GLOBAL SAFETY FIELD INVESTIGATIONS
DCS6612
URGENT - DISTRIBUTE IMMEDIATELY

Subject: N222365910 - Customer Satisfaction Program
Air Suspension Dump Valve

Models: 2022 Chevrolet Silverado 4500 HD/5500 HD/6500 HD
Equipped with VALVE-AIR SUSPENSION AIR RELEASE (RPO JPZ)

N222365910 Air Suspension Dump Valve

6318345

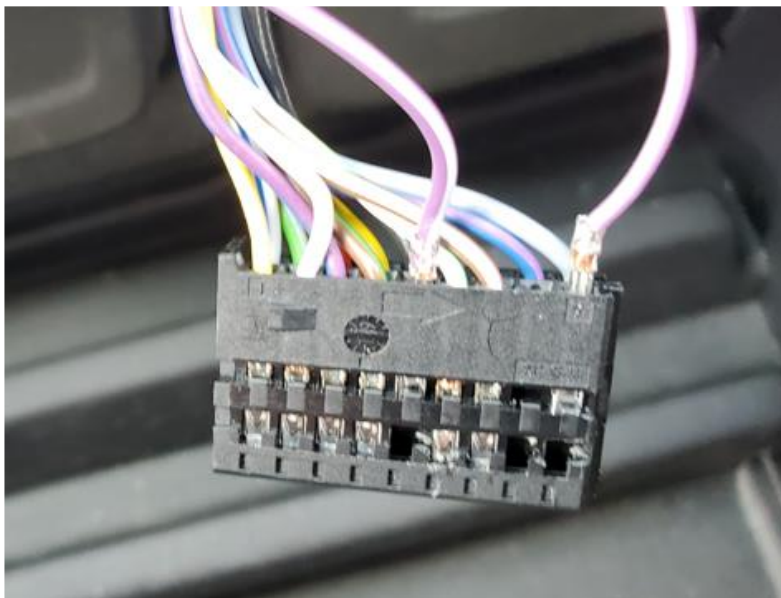
- Original Owner Letter provided by General Motors.
 - Vehicle registration.
 - Driver's license or state ID - verify that it matches the registration and owner letter.
1. Issue the customer a reimbursement check in the amount of \$60.00 USD. Record the check number in the Invoice Number field and record the VIN on the check.
 2. Remove the instrument panel center accessory function switch and discard. Refer to *Instrument Panel Center Accessory Function Switch Replacement* in SI.
 3. Disconnect the air suspension dump valve switch connector (18 pin connector).

4. Remove the 2 violet with white stripe wire terminals (Pin 5 and pin 9) from the 18 pin connector.
5. Cut both violet with white stripe wires 2 inches from the harness connector and wrap each wire with electrical tape.
6. Wrap both cut wires to the harness with anti-abrasive tape and secure with a tie strap the wire harness.
7. Connect air suspension dump valve switch connector to the new instrument panel center accessory function switch.
8. Install the new instrument panel center accessory function switch. Refer to *Instrument Panel Center Accessory Function Switch Replacement* in SI.
